# RB140-06/07

# RB142-06/07

# RB143-06/07

## RB144-06/07

**FIGURE R403.4(1)**  
**BASEMENT OR CRAWL SPACE WITH PRECAST FOUNDATION WALL BEARING ON CRUSHED STONE**

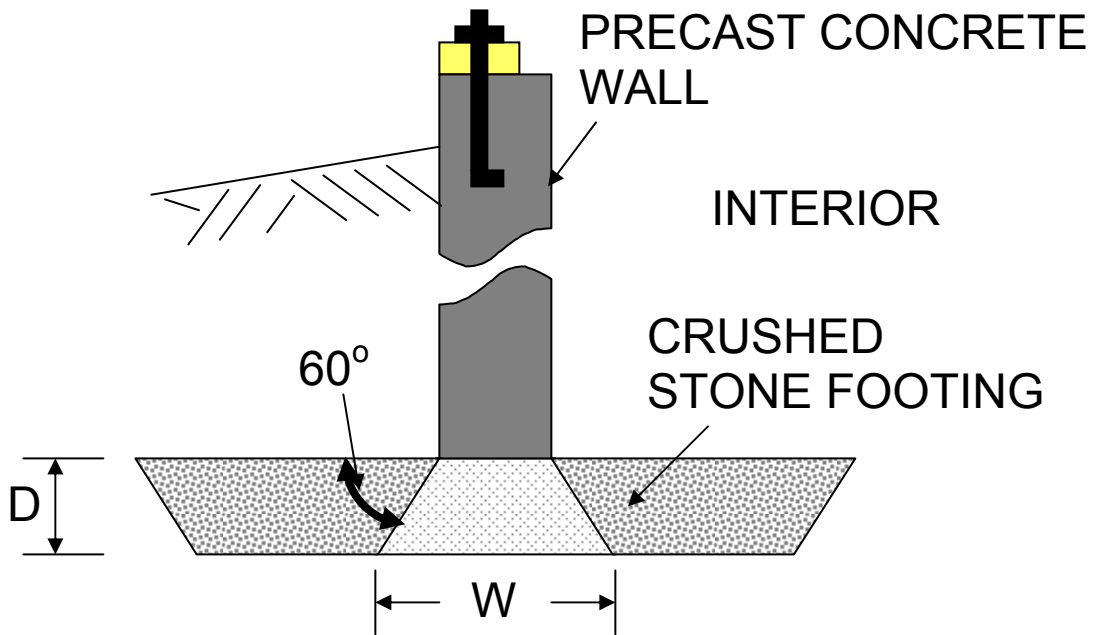
**R403.4.1 Crushed Stone Footings.** Clean crushed stone shall have a maximum size of ½ inch (12.7 mm). Crushed stone footings for precast foundations shall be installed in accordance with Figure R403.4 (1) and Table R403.4 (1). Crushed stone footings shall be consolidated using a vibratory plate in a maximum of eight-inch lifts.

**FIGURE R403.4(2)**  
**BASEMENT OR CRAWL SPACE WITH PRECAST FOUNDATION WALL ON SPREAD FOOTING**

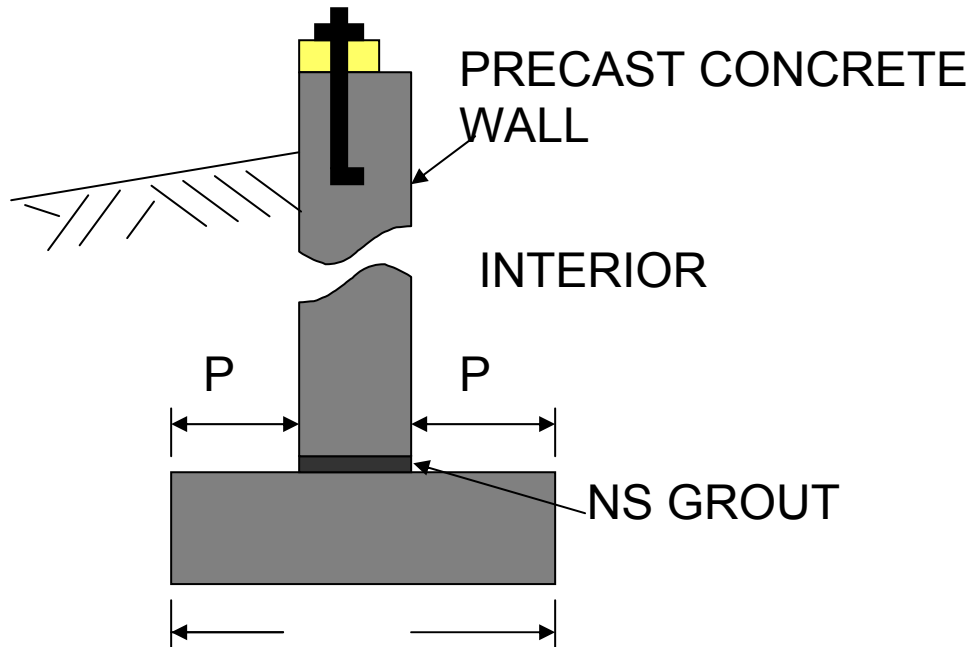
**R403.4.2 Concrete Footings.** Concrete footings shall be installed in accordance with Section 403.1 and Figure R403.4 (2).

**FIGURE R403.1.2  
HIGH WIND FOUNDATION DETAILS**

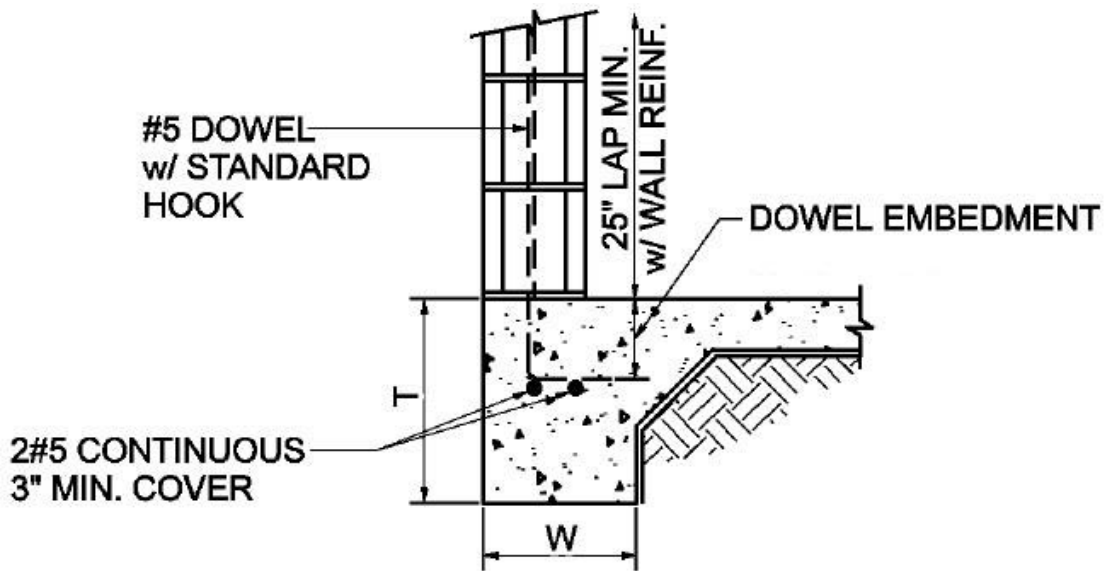
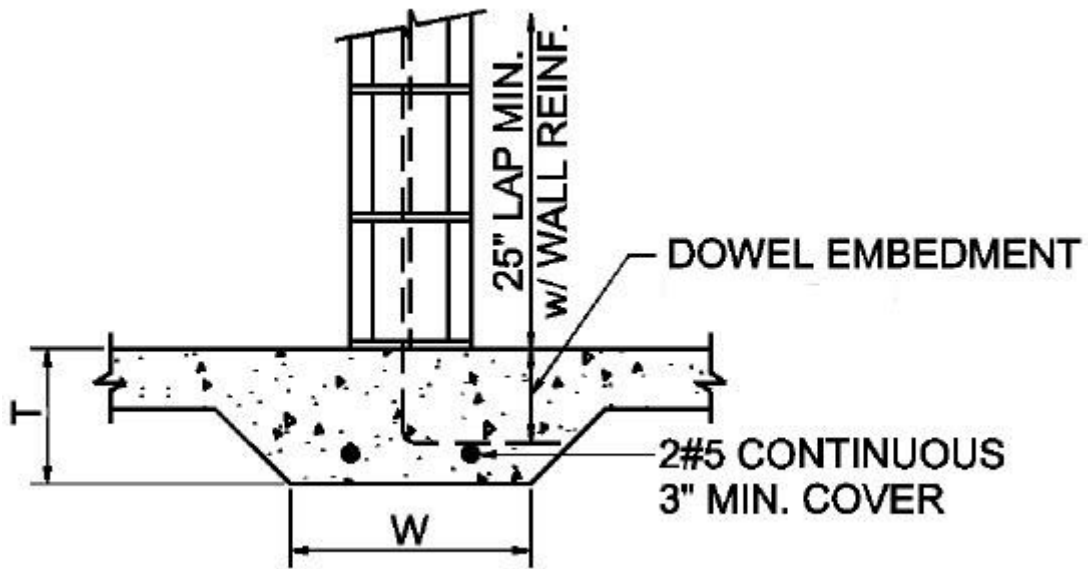
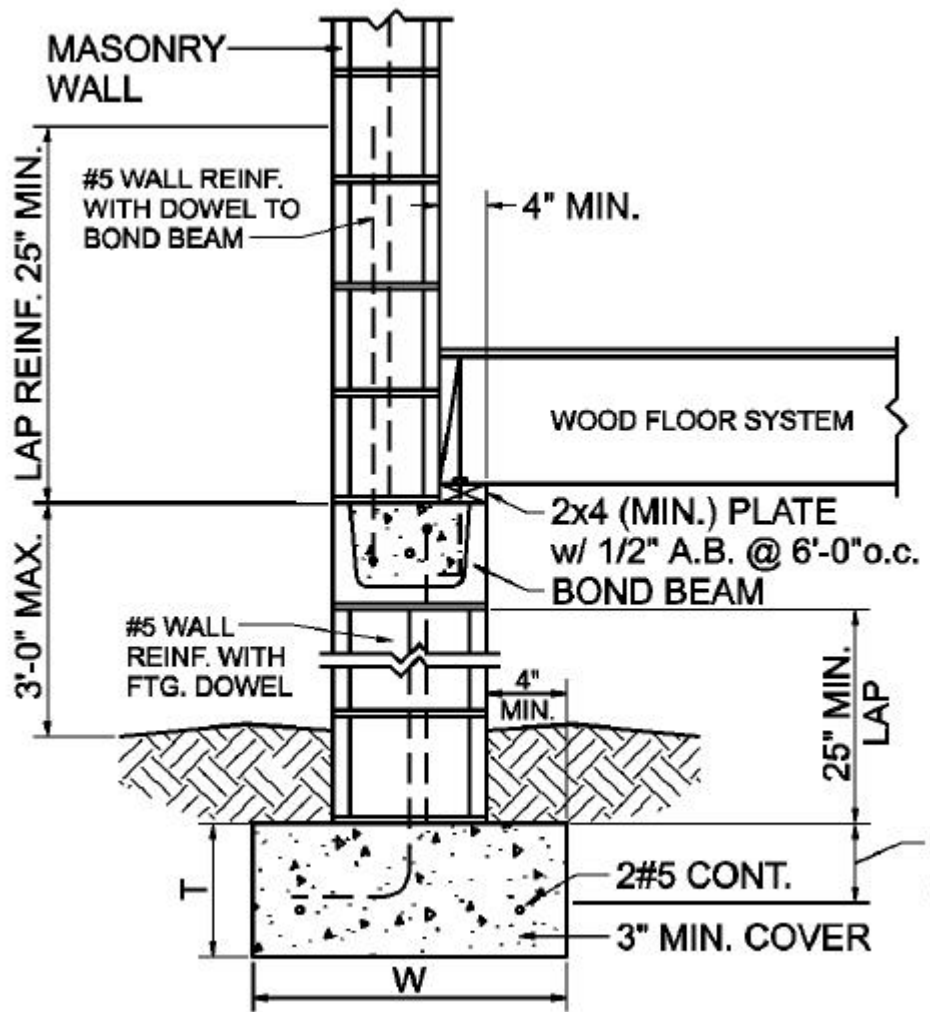
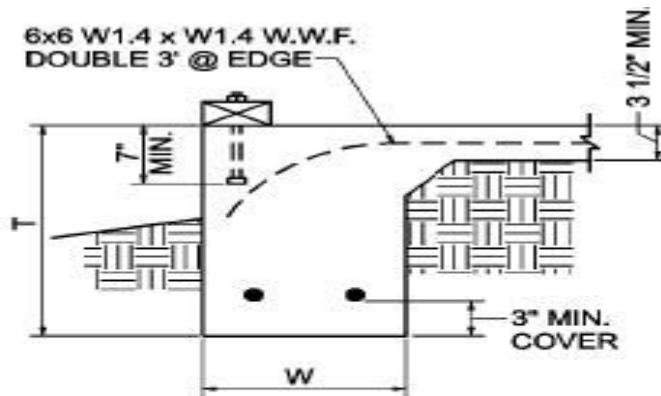
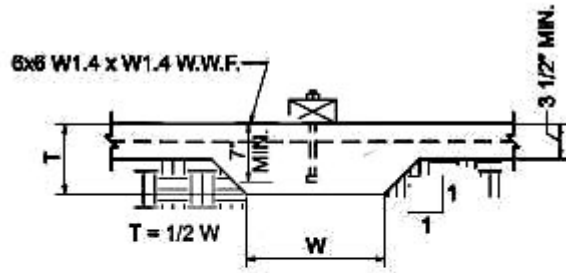
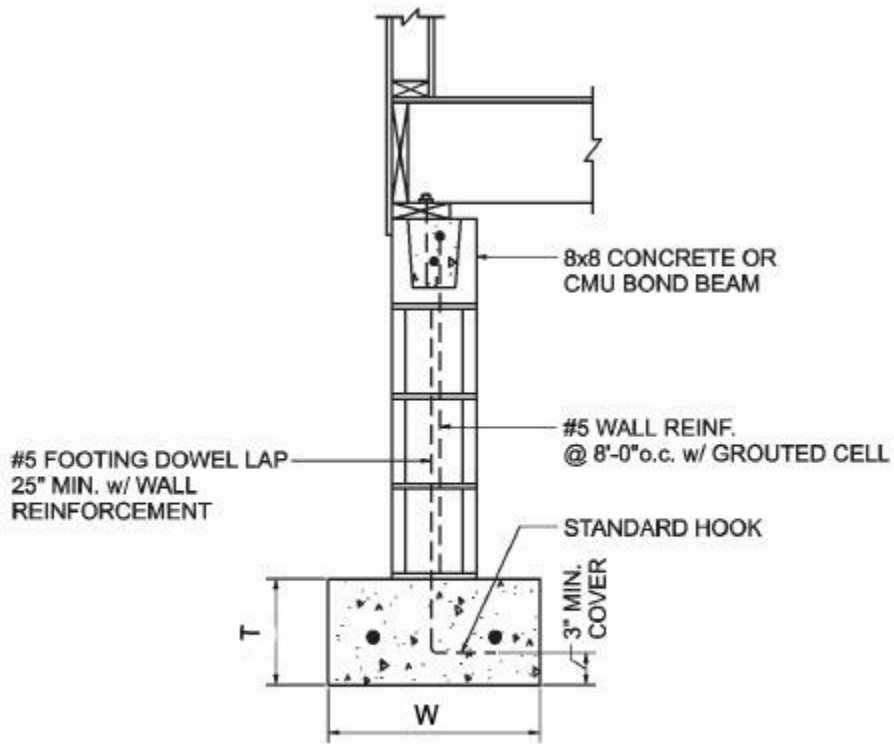
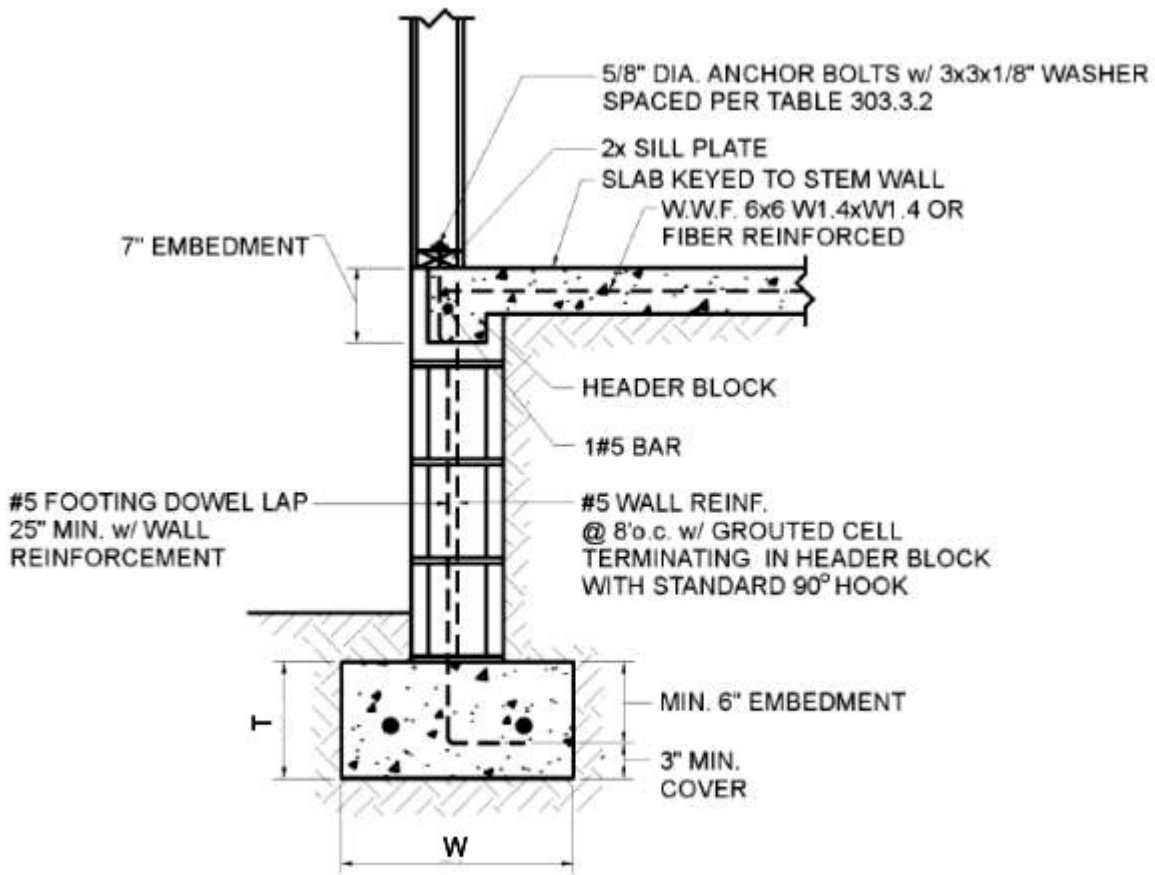
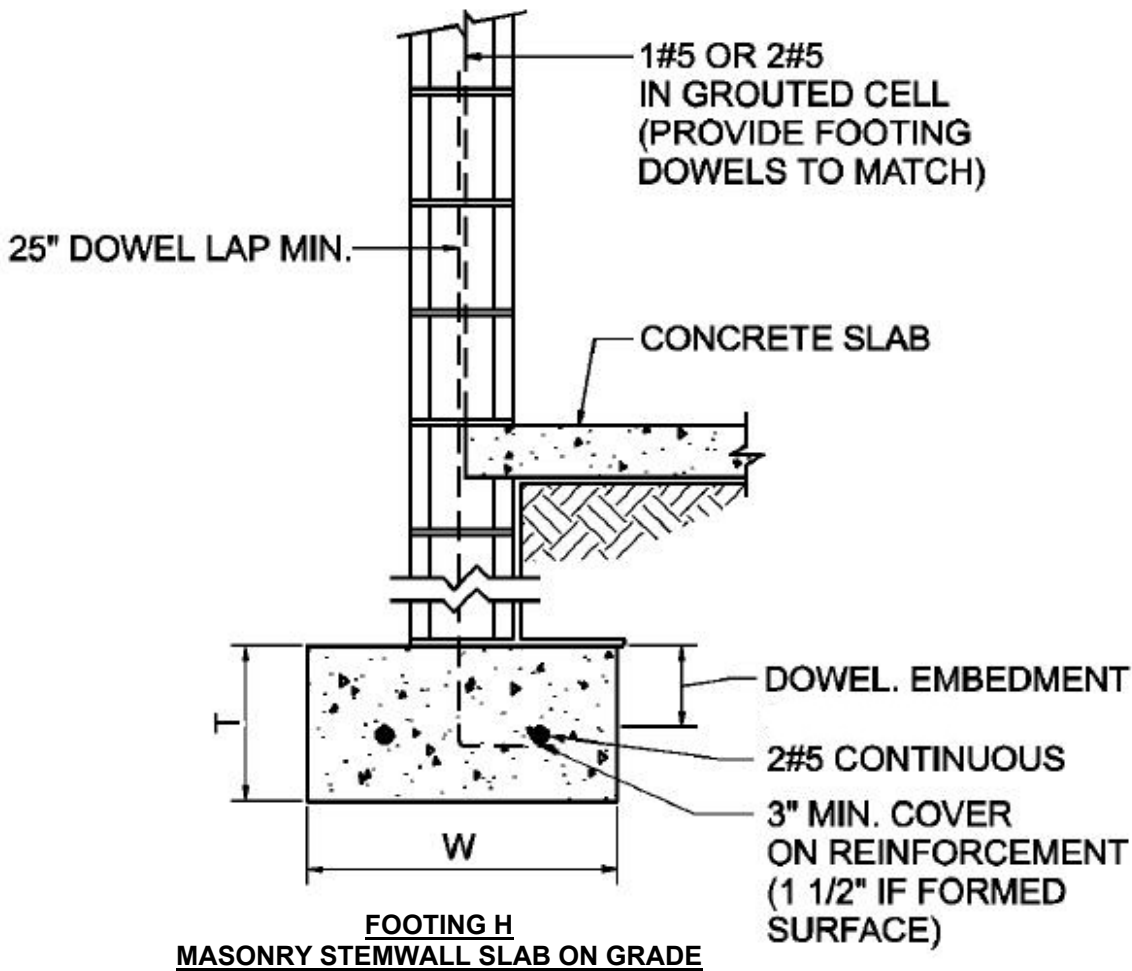
**R403.1.2. High wind regions.** In regions where the basic wind speeds from Figure R301.2(4) equal or exceed 100 miles per hour (45 m/s) in hurricane-prone regions, or 110 miles per hour (49m/s) elsewhere, concrete and masonry footings shall also be sized to provide adequate resistance to uplift and overturn of the building as determined from Table 401.1 or as calculated using engineered design in accordance with the International Building Code. Uplift resistance of common foundations are given in Table R403.1.2. Uplift resistance of these foundations may be increased by increasing the size of the concrete footing. When determining the modified uplift resistance the added weight shall be reduced by multiplying by a factor of 0.6. Other foundation systems shall be engineered in accordance with the *International Building Code*.

**FIGURE R403.1.3.2**  
**DOWELS FOR SLABS-ON-GROUND WITH TURNED-DOWN FOOTINGS**

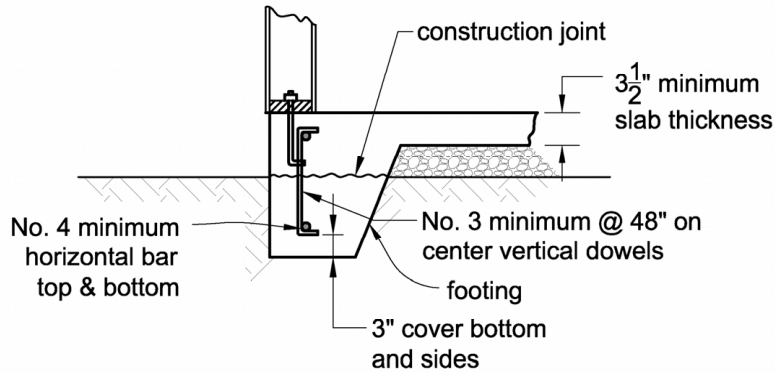
Where the slab is not cast monolithically with the footing, No. 3 or larger vertical dowels with standard hooks each end shall be provided in accordance with Figure R403.1.3.2.

**Reason:** The exception is revised because placement of the reinforcing at the top and bottom of the footing provides much better crack control and stiffness and should always be an option. The addition of vertical dowels in slabs cast separately is in response to observation of wide-spread damage due to slippage on the construction joint during the 1994 Northridge Earthquake.
